| Model: Model C-P1 | | Date: 17-Sep-03 | No.: RG094001 |
| Subject: Printer Controller Firmware History | | Prepared by: T.Shintani | |

| Model: Model C-P1 | | Date: 26-Apr-04 | No.: RG094002 |
| Subject: Engine Board | | Prepared by: A. Ishiyama | |

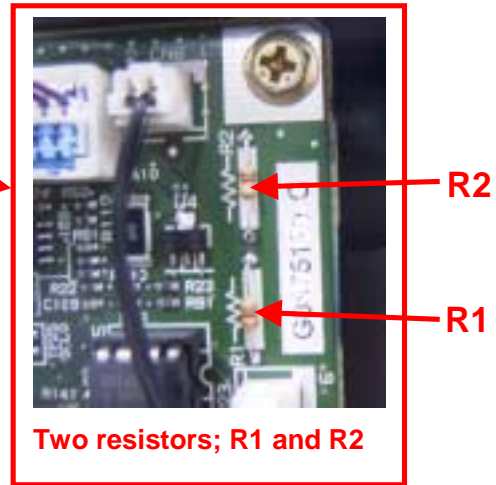
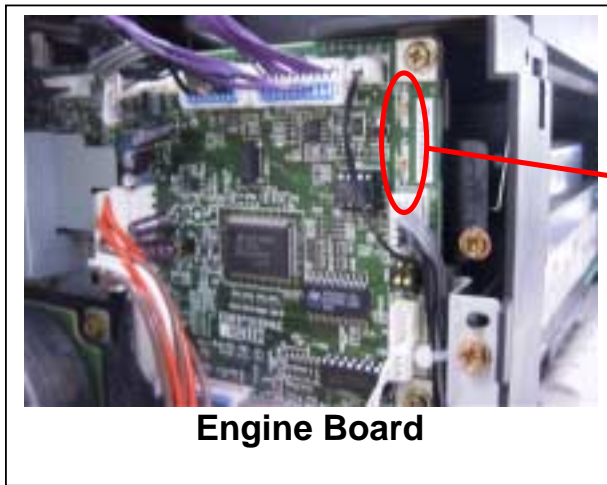
● Possible Symptoms with the Unmodified Old Boards

The following may occur when using the unmodified old boards, but please note that even in such cases the machine is well within product safety parameters.

- A PPM (print per minute) decrease from 25ppm to 20ppm, as the old board control configuration is for the Japan model.
- Fusing-related symptoms (e.g. poor fusing, paper curling), the machine may not satisfy certain EU regulations.
- Discrepancy between the paper size dial setting and the LCD display, which may result in a paper size error or paper jam.
- Garbled characters may be displayed when using display languages other than English.

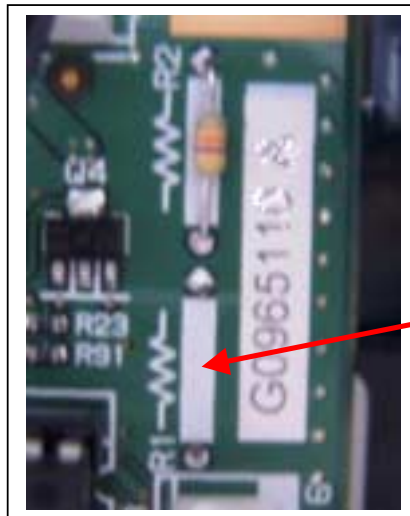
The old engine board (G0965116) contains two resistors, R1 and R2, but the new board for NA (G0985102) contains only R2 and the new board for EU/Asia (G0985104) contains only R1.

Minor Modification of old G0965116 Engine Board to its New Version

1. If the old engine board is already installed in the machine:
 - i) Open the front door.
 - ii) Remove the operation panel (2 hooks, 1 harness).
 - iii) Remove the rear cover.
 - iv) Remove the top cover (4 screws).
 - v) Remove the left cover (2 screws).

2. **For NA version**
 Remove R1 as shown below using a pair of wire cutters (nippers).

Remove R1 using a pair of wire cutters

For EU/Asia version

In the same manner, **remove R2 using a pair of wire cutters.**
